Title Volvo Chassis - Windshield Wiper Function Inoperative In Intermittent Mode **ONLY**;
Wiper Intermittent Setting Not Working - **Model Year 2018 to 2020**

Volvo Model VNL , VNR , VNX , VAH , VHD

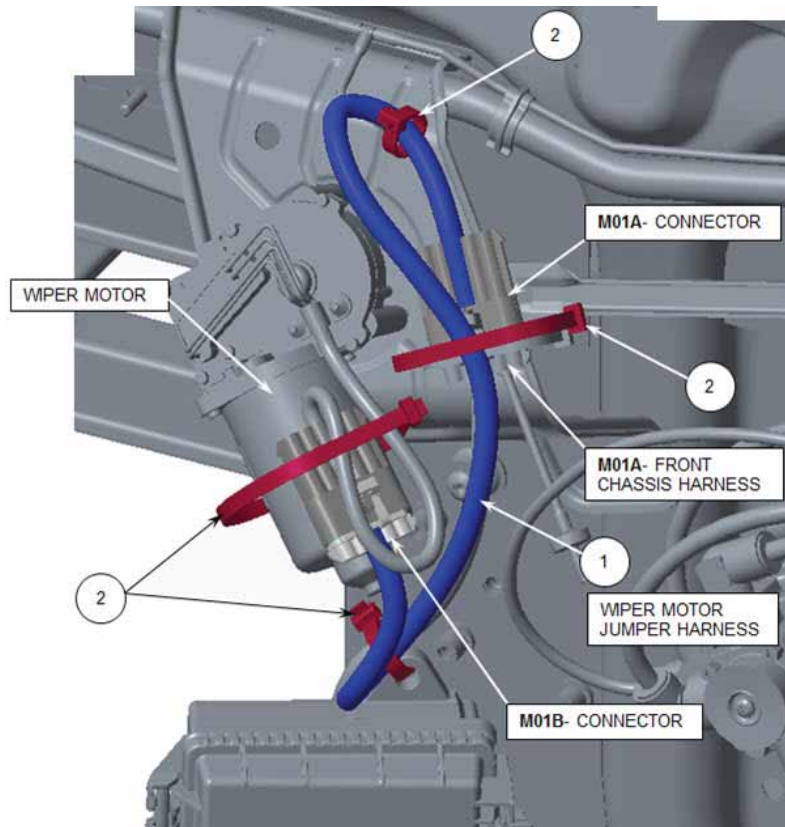
Cause For vehicles model year 2018 to 2020, the windshield wipers may not function when the intermittent setting is selected. This condition may result from wiper motor contact with the motor slip ring, resulting in the current from the Light Control Module (LCM) to the Wiper Motor to be too low.

Solution A partial containment will be for the installation of a jumper harness that contains a resistor to increase the current flow to the motor slip ring. Future containment will be a new cab harness that will be a new cab harness that will have the resistor integrated.

1. Order Harness Jumper 23522546.
2. Install the jumper harness as shown in the picture below.
